Operations Bulletin

Bulletin 90

Hinged Hydrant Pit Lids

May 2016

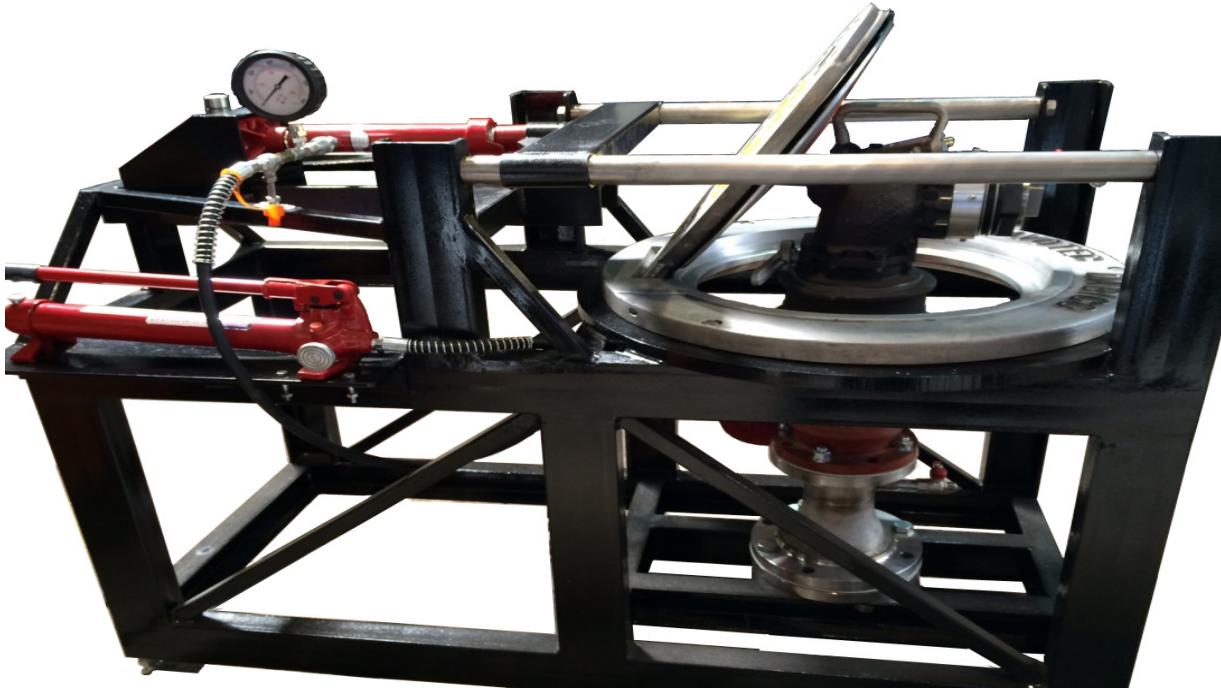
A number of stakeholders have raised concerns that non-lay-flat hinged hydrant pit lids may interfere with the breakaway characteristics of EI 1584 Third Edition Hydrant Pit Couplers. The concern is that if the lid is contacted by a moving apron service vehicle then it could trap the hydrant pit coupler in a clamshell type action preventing it from breaking away cleanly as it is designed to do – continued pressure on the lid could result in a partial breakaway or pit coupler casing fracture and the potential risk of a pressurised release of fuel from the hydrant. The effect this would have on the hydrant riser pipe is not known.

It is clear that the presence of the non-lay-flat lid generates a downward force on the hydrant pit coupler that does not arise with a lay-flat lid. In the absence of further testing, including stress measurement, Hydrant Operators shall specify the lay-flat type for any new purchases of hinged hydrant pit lids.

Manufacturers of non-lay-flat hinged hydrant pit lids may be able to propose a modification to the lid arrangement. Hydrant Operators shall either change existing non-lay-flat hinged hydrant pit lids to lay-flat lids or modify existing non-lay-flat hinged hydrant pit lids as recommended by the manufacturers, as soon as practical and no later than the end of December 2018. Modified lids shall continue to meet the JIG requirement of either being permanently connected or tethered to the pit. To achieve this requirement, it is recommended that equipment suppliers be contacted as soon as possible.
